Important Information — Dell OptiPlex 790/990

System Board

Figure 2. System Board with the thermal sensor and heatsink removed

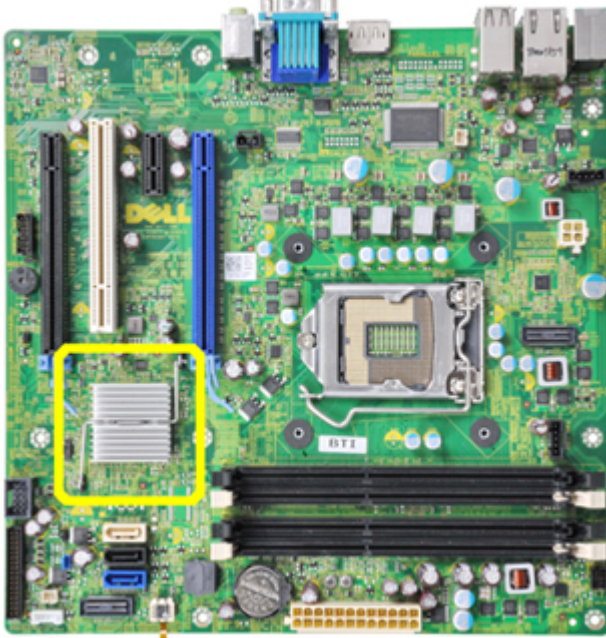
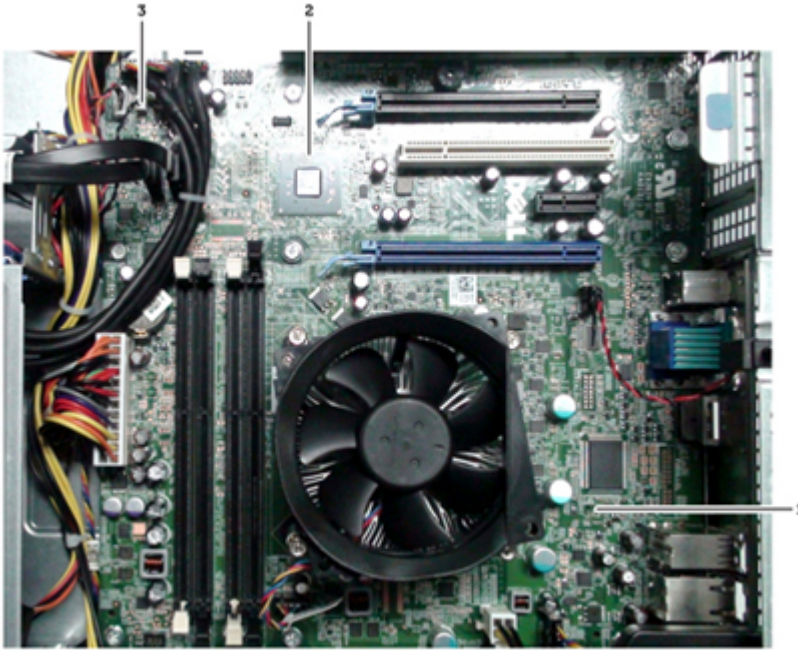
The Dell OptiPlex 790/ 790 computers are now shipped with a new system board without the following components:

1. Heatsink
2. Power supply thermal sensor (Desktop chassis only)

The following image displays an earlier version of the system board shipped with the heatsink.

The power supply thermal sensor is removed from the desktop chassis only.

1. thermal sensor connector-1 and cable removed
2. chipset heatsink removed
3. thermal sensor connector-2

All system boards shipped with the following BIOS versions or higher will NOT contain the heatsink.

NOTE: If you have replaced your system board with a new system board for the Desktop chassis, always ensure that the BIOS version is A11 or higher.

WARNING: If you do not update the BIOS, you may receive Alert! Chipset heat sink not detected error message during the power-on self test (POST).
